**BOROUGH OF HIGHLANDS**  
**LAND USE BOARD MEETING**  
22 Snug Harbor Avenue, Highlands NJ 07732  
Thursday, March 10, 2022 at 7:00 PM

**AGENDA**

REV	DATE	DESCRIPTION	BY	CHECK			
MINOR SUBDIVISION PLAN FOR <b>THOMAS FAHEY</b> LOT 6 BLOCK 14 SHEET 6 BOROUGH OF HIGHLANDS, MONMOUTH COUNTY, NEW JERSEY RICHARD E. STOCKTON & ASSOC., INC. SURVEYING & MAPPING->PLANNING->CONSTRUCTION SURVEYING PO BOX 124, ATLANTIC HIGHLANDS, NJ 07716, 732-872-2827							
RICHARD STOCKTON, LICENSED PROFESSIONAL LAND SURVEYOR & PLANNER PLS15102 PP2267							
DATE:	9-30-21	FILE:	4276	DRAWN:	RLT	JOB NO:	8158
SCALE:	1" = 20'	CAD#:	P-8158sub1.dwg	CHECKED:	Res	DWG NO:	D-1047

**Re: Farrell Residence  
 32 Shrewsbury Avenue  
 Block 43, Lot 7  
 Waterfront Transition-Residential (WT-R) Zone  
 Minor Site Plan with variances  
 First Engineering Review**

**DRAWING:**  
 FOUNDATION PLAN  
 GARAGE FLOOR PLAN  
 GARAGE ELEVATIONS  
**DATE:**  
 NOVEMBER 11, 2021  
**REVISED:**

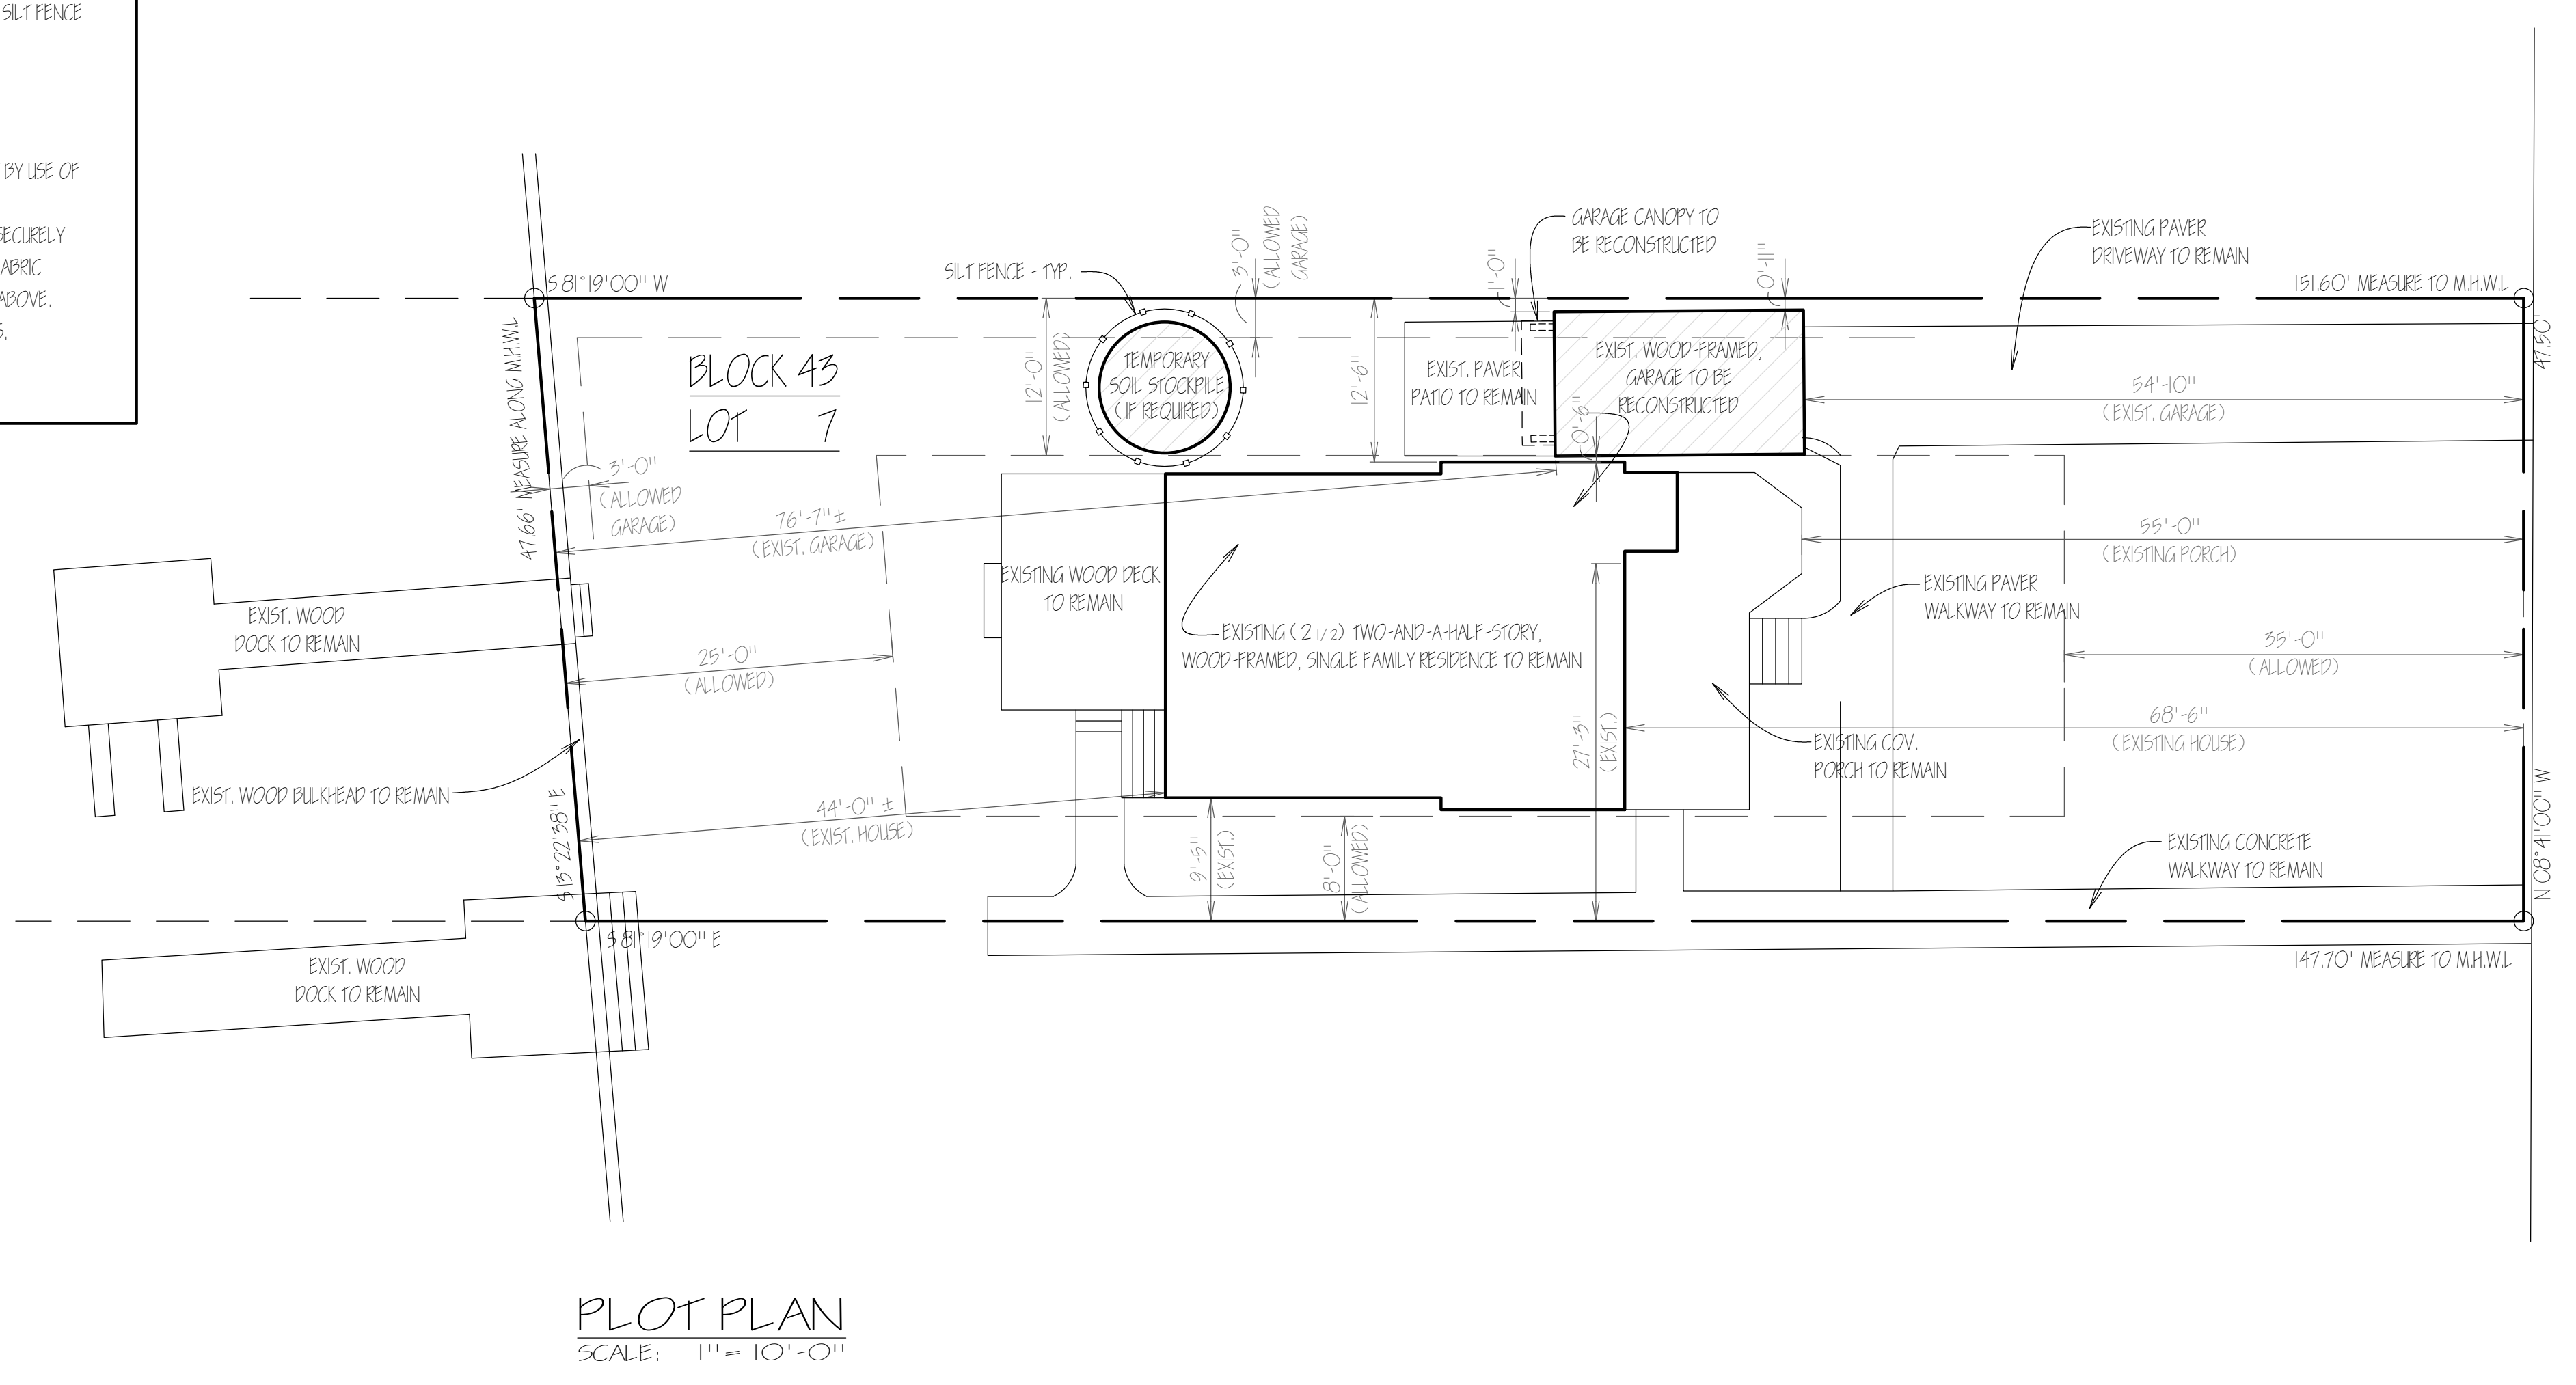
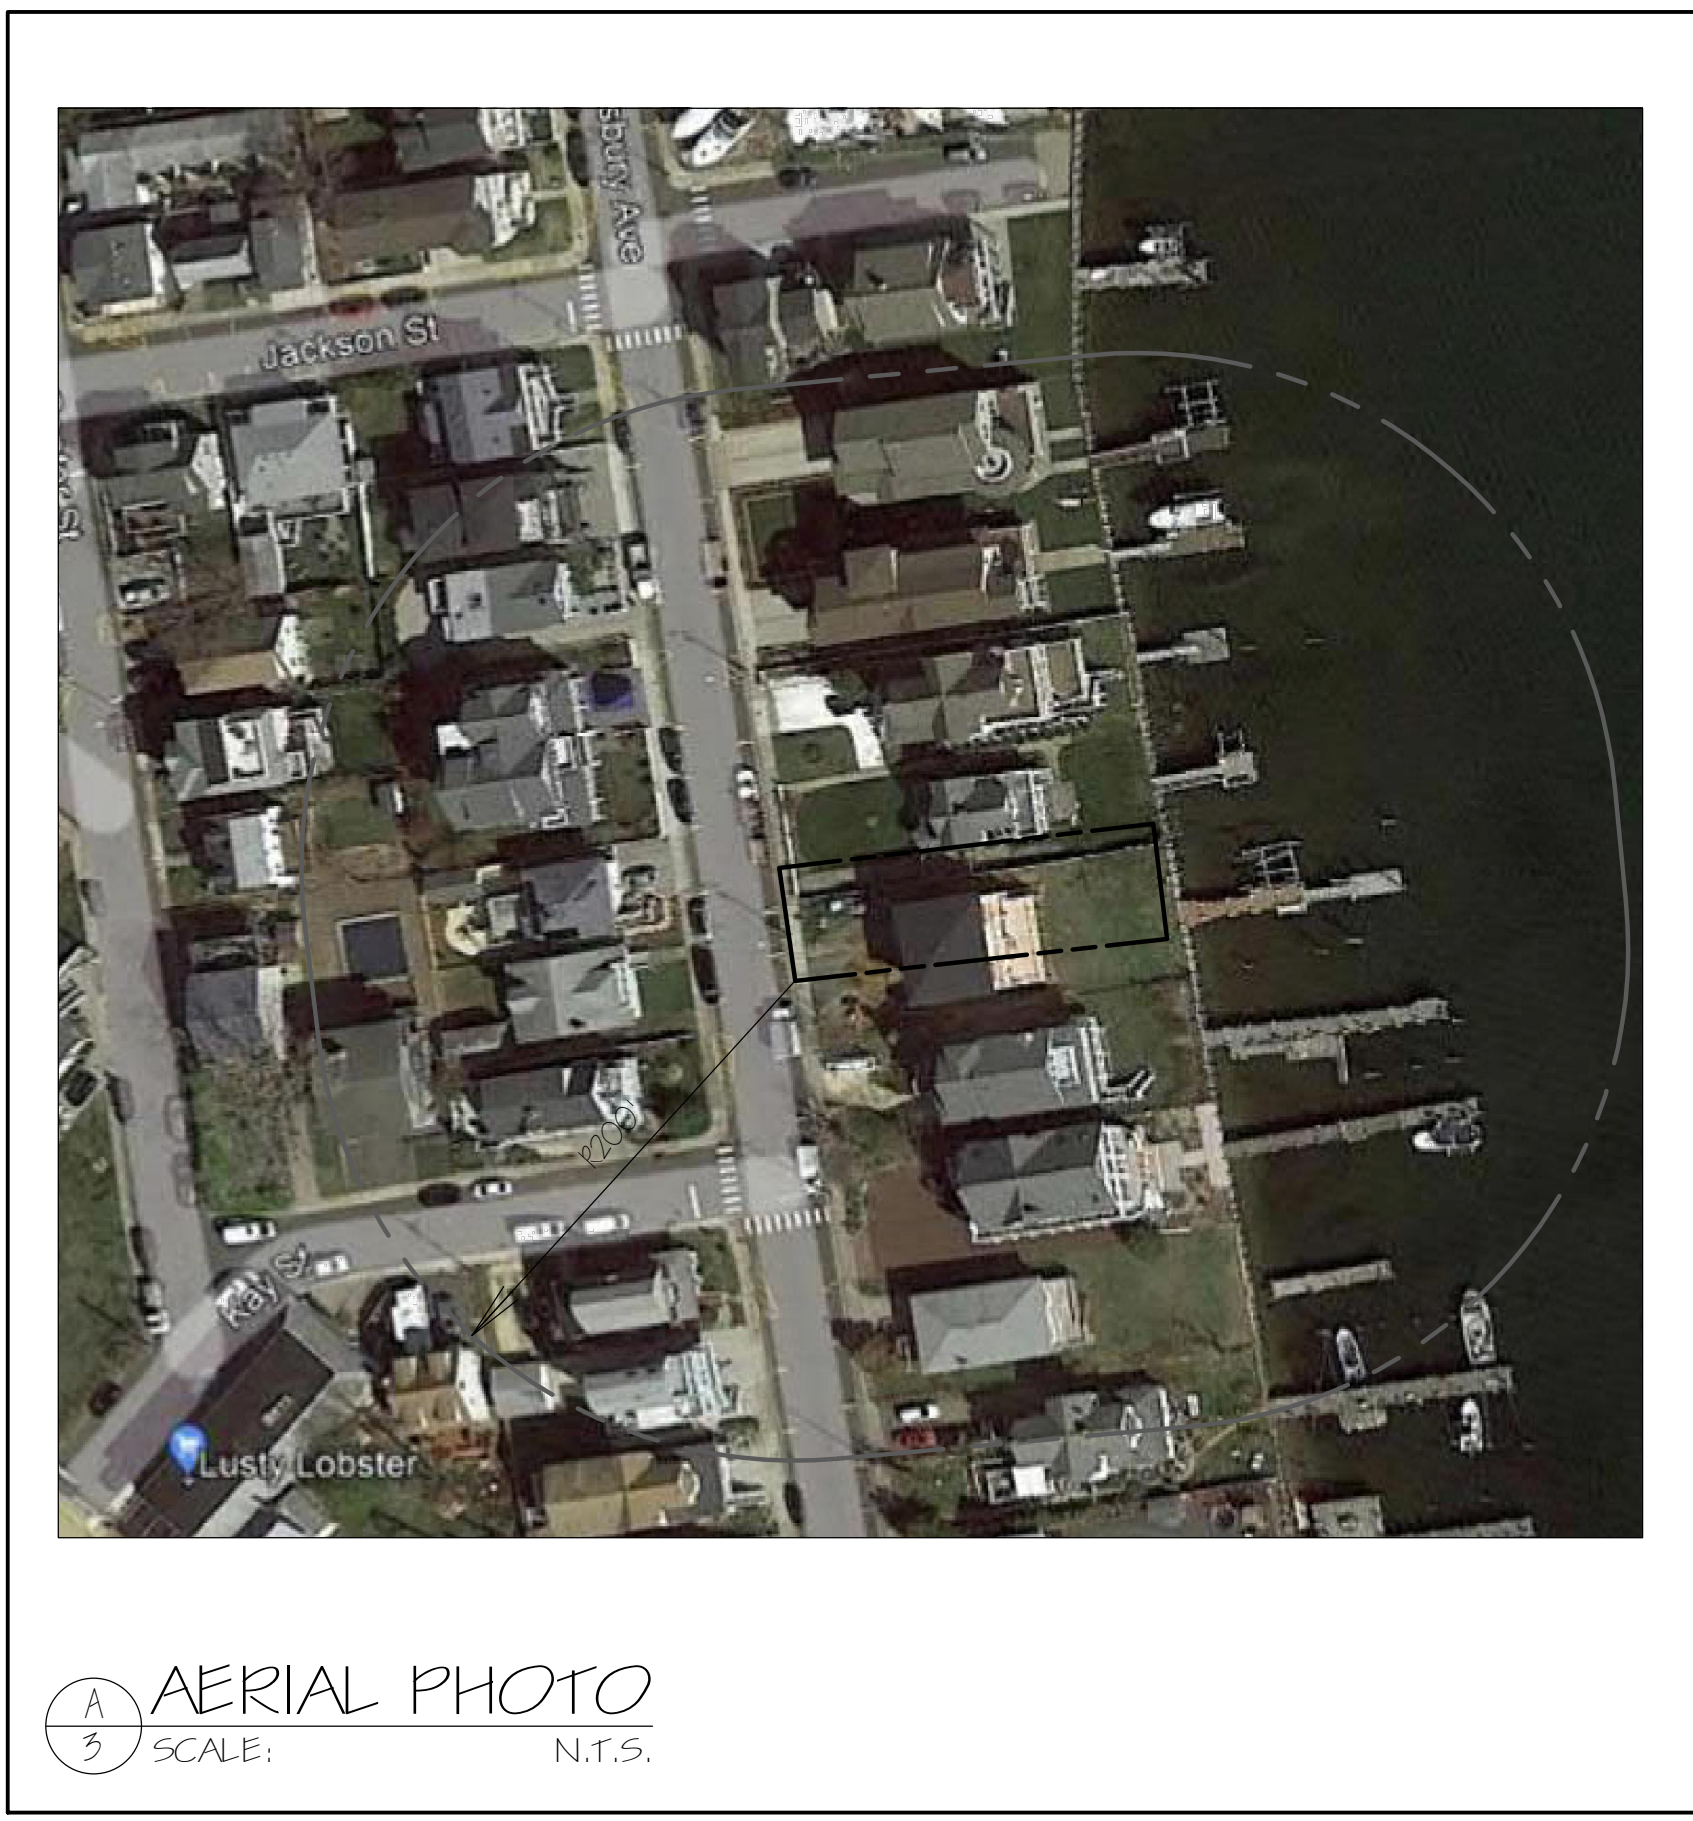
1. The applicant shall provide testimony regarding the prior existence and/or approvals for the accessory garage that is the subject of this application, as well as the circumstances surrounding its demolition. Pursuant to Ordinance Section 21-98.C:

4. The applicant shall provide testimony on how the garage was damaged and the need for its reconstruction.
5. Pursuant to Ordinance Section 21-65.10A (Landscaping and Street Trees), “All areas not devoted to structures, paving, or other required uses shall be appropriately graded, landscaped and maintained in accordance with a landscaping plan approved by the Board”. The Board should determine if a landscaping plan is required.

7. The applicant shall provide testimony on any drainage impacts to the adjacent residential properties as a result of this application.

8. A note shall be added to the plans stating that any/all existing curb, sidewalk, roadway, and other off-site objects damaged by construction should be repaired and/or replaced to the satisfaction of the Borough Engineer.
9. Approvals or waivers should be obtained from any agencies or departments having jurisdiction.

18. Preliminary architectural plans for the proposed buildings or structures indicating typical floor plans, elevations, heights and general design or architectural styling. **Provided. The proposed structure is located within the Limit of Moderate Wave Action (LimWA) in flood zone AE-13. Therefore, the plans should be designed in accordance with FEMA standards and the Borough of Highlands Flood Damage Prevention Ordinance requirements. I defer to the Borough Floodplain Manager for further review.**
